PICkit 3 Operation at Low Voltage - Modification

Figure 1

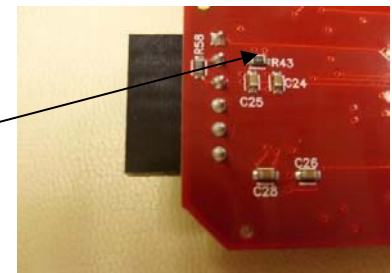
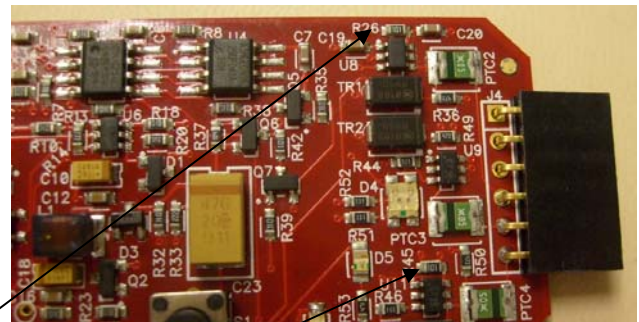
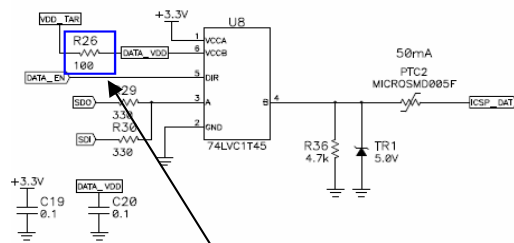
Problem: The PICkit 3 clock and data buffers have a series resistor in the VDD path to limit current. During an ICSP operation, the output voltage of the buffers may decay sufficiently when operating at low voltage to cross the minimum threshold of operation of the device.

Solution: There are several workarounds. One solution is to simply use external target power where the voltage regulation of the external power supply is 1% or better of the desired level and ensure the current supplied is at least 50ma. Another solution is to simply increase the voltage in MPLAB IDE to compensate for the voltage drop across the resistor. The last and more permanent solution is to change the resistors (R26, R43, and R45) in the CLOCK, DATA, and LVP buffer path from 100 ohms to 0 ohms so the voltage drop is eliminated. See figure 1 for rework details.

Replace (R26) with 0 ohms or jumper wire.
The same modification can be made to the LVP (R45)
and CLOCK (R43) nodes.
